PLANNING CLEARANCE
(Single Family Residential and Accessory Structures)
Grand Junction Community Development Department

BLDG ADDRESS 2387 Mariposa Dr. TAX SCHEDULE NO. 2945-201-11-002
 SUBDIVISION The Ridges SQ. FT. OF PROPOSED BLDG(S)/ADDITION 1876
 FILING 3 BLK 19 LOT 2C SQ. FT. OF EXISTING BLDG(S) _____
 (1) OWNER G.A. Garrett NO. OF DWELLING UNITS
 BEFORE: 0 AFTER: 1 THIS CONSTRUCTION
 (1) ADDRESS 2386 West Plateau Ct.
 (1) TELEPHONE 243-2572 NO. OF BLDGS ON PARCEL
 BEFORE: _____ AFTER: _____ THIS CONSTRUCTION
 (2) APPLICANT SAME USE OF EXISTING BLDGS _____
 (2) ADDRESS _____ DESCRIPTION OF WORK AND INTENDED USE: _____
 (2) TELEPHONE _____ New Home Construction

HOUSE LOCATION ON
LOT 2C, BLOCK 19,
THE RIDGES FILING 3

► APPROVAL FOR BUILDING PERMIT ◀
 Ridges Architectural Control Committee (ACCO)

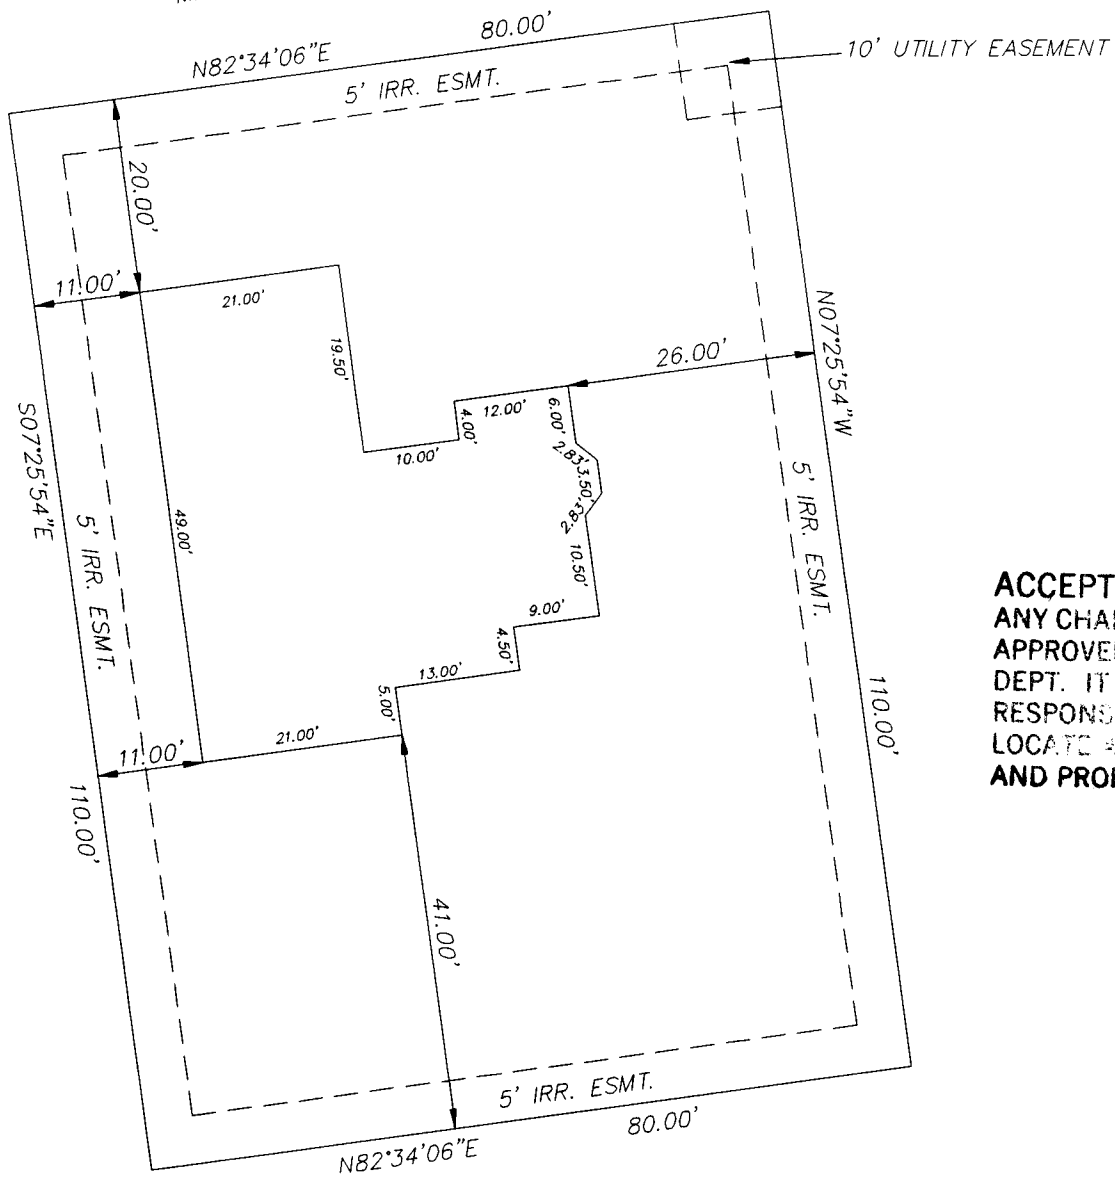
ACCEPTED *ml 10-11-94*
ANY CHANGE OF SETBACKS MUST BE APPROVED BY THE CITY PLANNING DEPT. IT IS THE APPLICANT'S RESPONSIBILITY TO PROPERLY LOCATE AND IDENTIFY EASEMENTS AND PROPERTY LINES.
